## ADDENDUM #2

Reference: Extended Education Building Improvements  
Utah Valley University – Orem, Utah  
Project No.10011790

**DATE:** April 28, 2010  
**PROJECT NO:** 10096  
**PROJECT:** UVU Extended Education  
Building

**SD-01**  
**M-100**

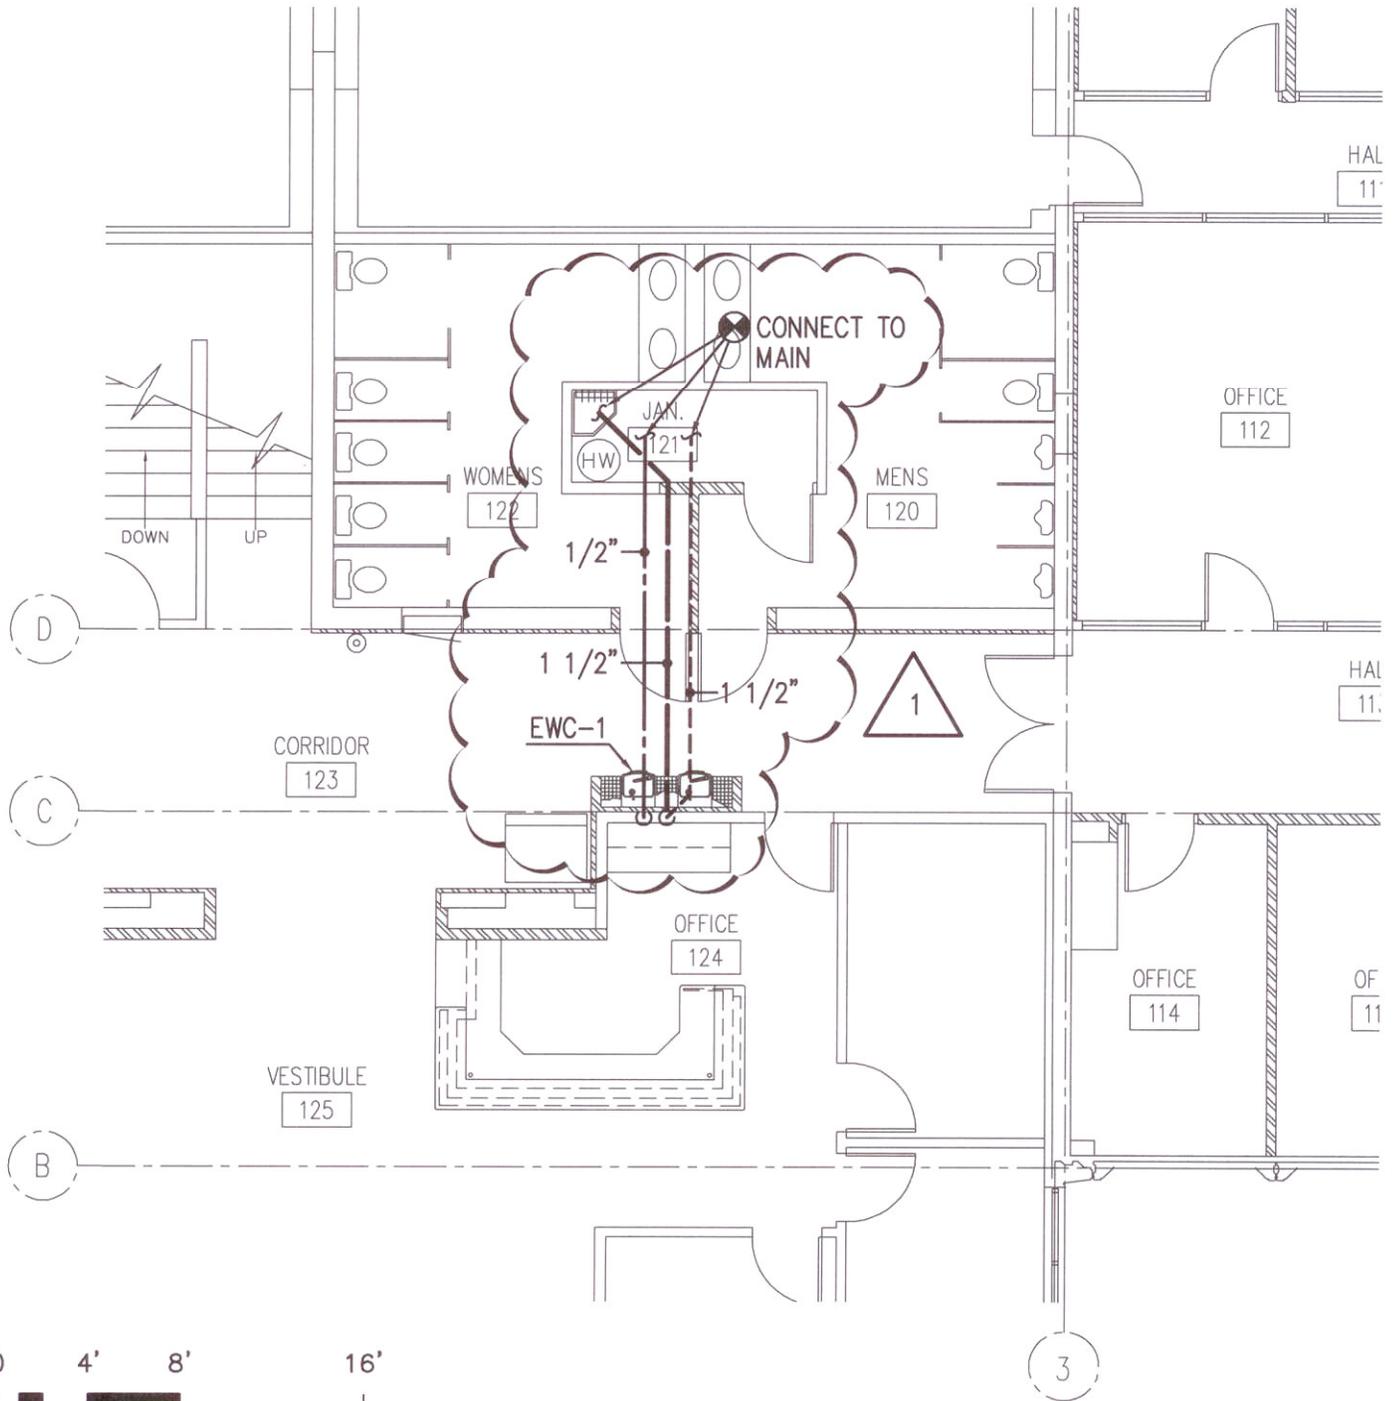
1. Extend and connect new supply and return grilles in Office 100. Balance diffusers to CFM shown on supplementary drawing. 10/10 return duct shall be 12/12. See attached supplementary drawing for duct sizes, locations, CFM, etc.

2. Extend 1/2" domestic cold water line from existing mains in Janitor 121, and connect to new Electric Water Cooler, EWC-1. Coordinate exact location of existing piping with existing conditions. Patch and repair damaged ceiling, walls, etc. due to construction to match existing. See supplementary drawing and attached specification.

3. Extend 1-1/2" waste and 1-1/2" vent line from existing mains in Janitor 121, and connect to new Electric Water Cooler, EWC-1. Coordinate exact location of existing piping with existing conditions. Patch and repair damaged ceiling, walls, etc. due to construction to match existing. See supplementary drawing and attached specification.

1  
SD2  
**TYPICAL RECESSED FIXTURE MOUNTING**  
NO SCALE

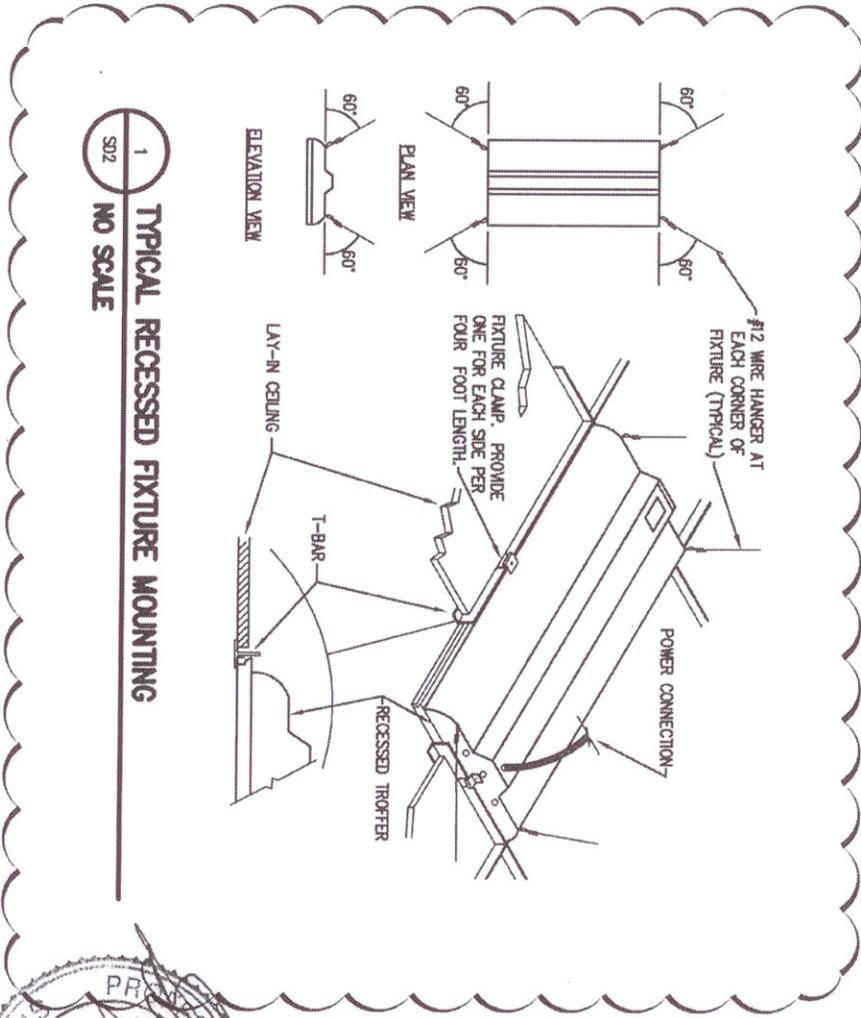
3. While the plans address the restraint requirements for the ceiling systems, they should also specify how the light fixtures are to be restrained. Please address.

Electrical Response: Please see the attached detail for the seismic restraint for lay-in light fixtures.
